GNRO-2015/00046

**SUBJECT:** Clarification to Fluence Methodology License Amendment Request letter  
GNRO-2014/00080 dated November 21, 2014 to include DRAFT marked-up  
UFSAR pages and a Regulatory Commitment to revise the GGNS UFSAR  
upon NRC approval of the Fluence Methodology LAR  
Grand Gulf Nuclear Station, Unit 1  
Docket No. 50-416  
License No. 29

**DRAFT Marked-Up Pages of Affected GGNS UFSAR Chapter 4**

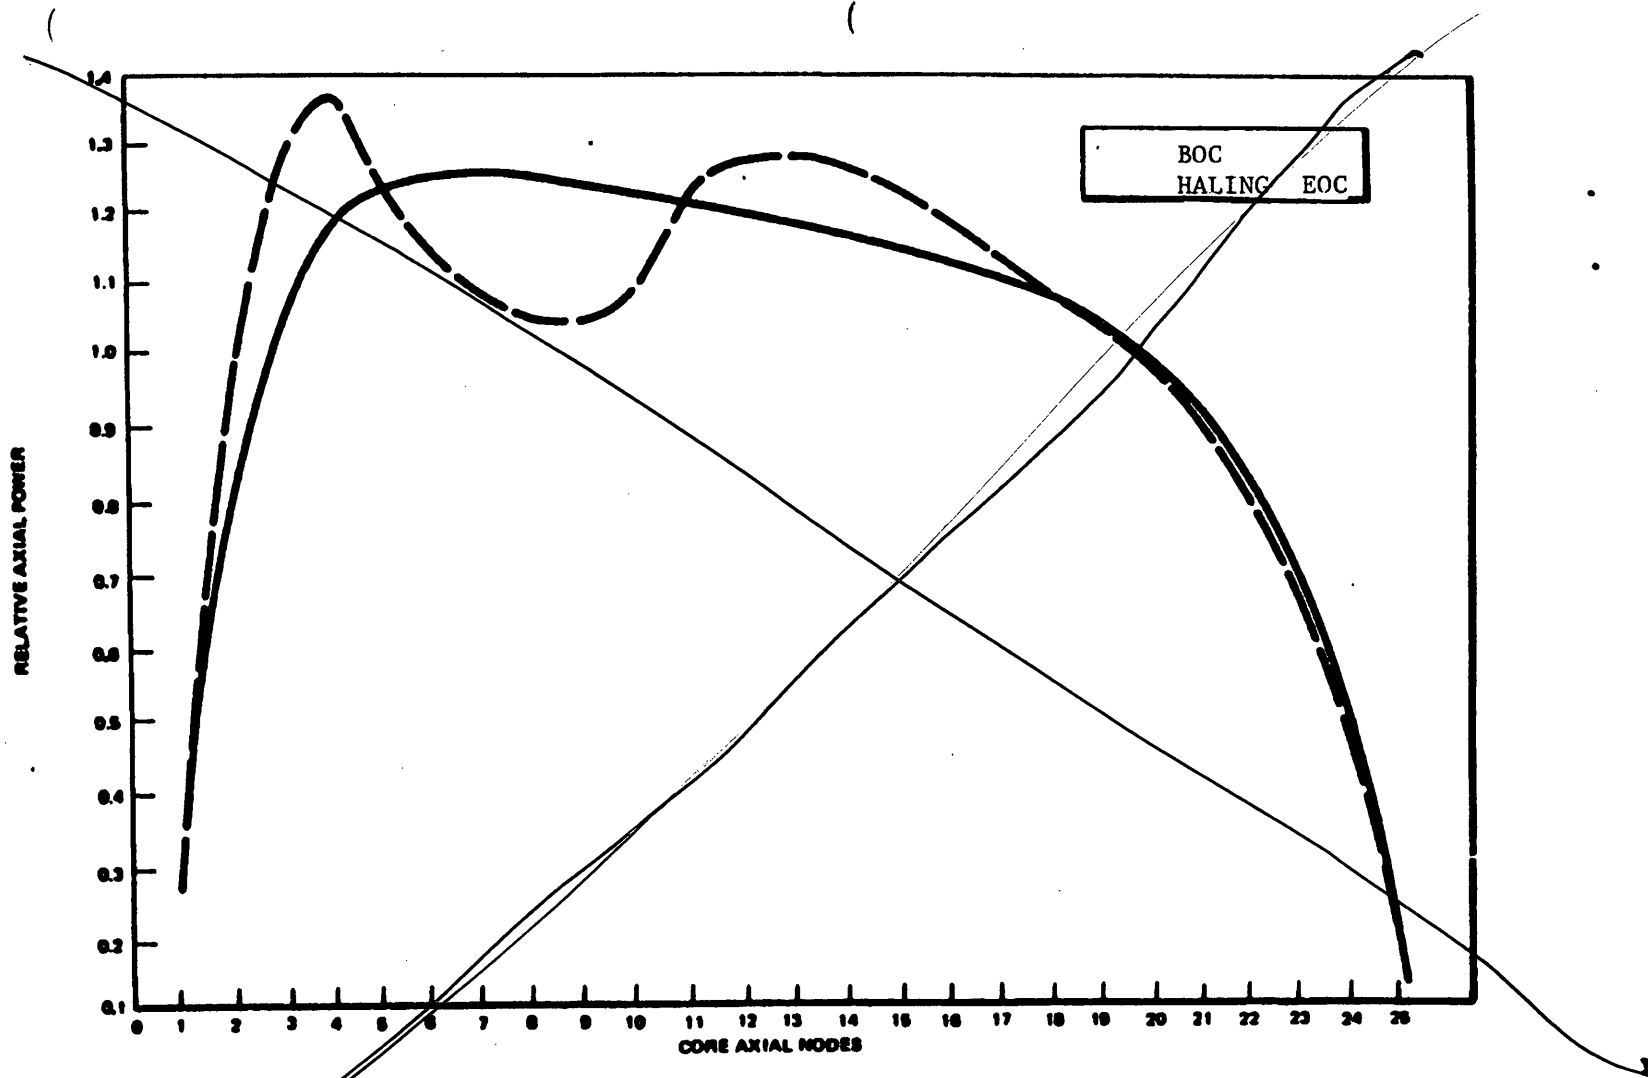
*three* The neutron fluxes at the vessel have been calculated using the ~~one-dimensional discrete ordinates~~ transport code described in subsection 4.1.4.5. ~~The discrete ordinates code was used in a distributed source mode with cylindrical geometry. The geometry described six regions from the center of the core to a point beyond the vessel. The core region was modeled as a single homogenized cylindrical region. The coolant water region between the fuel channel and the shroud was described containing saturated water at 550°F and 1050 psi. The material compositions for the stainless steel in the shroud and the carbon steel in the vessel contain the mixtures by weight as specified in the ASME material specifications for ASME SA 240, 304L, and ASME SA 533 grade B. In the region between the shroud and the vessel, the presence of the jet pumps was~~ *included* ~~ignored.~~ A simple diagram showing the regions, dimensions and weight fractions are shown in Figure 4.3-29.

*Insert 'c' New Paragraph*  
The distributed source used for this analysis was obtained from the gross radial power description. The distributed source at any point in the core is the product of the power from the power description and the neutron yield from fission. By using the neutron energy spectrum, the distributed source is obtained for position and energy. The integral over position and energy is normalized to the total number of neutrons in the core region. The core region is defined as a 1-centimeter thick disc with no transverse leakage. The power in this core region is set equal to the maximum power in the axial direction. The radial and axial power distributions are shown in Figures 4.3-30 and 4.3-22.
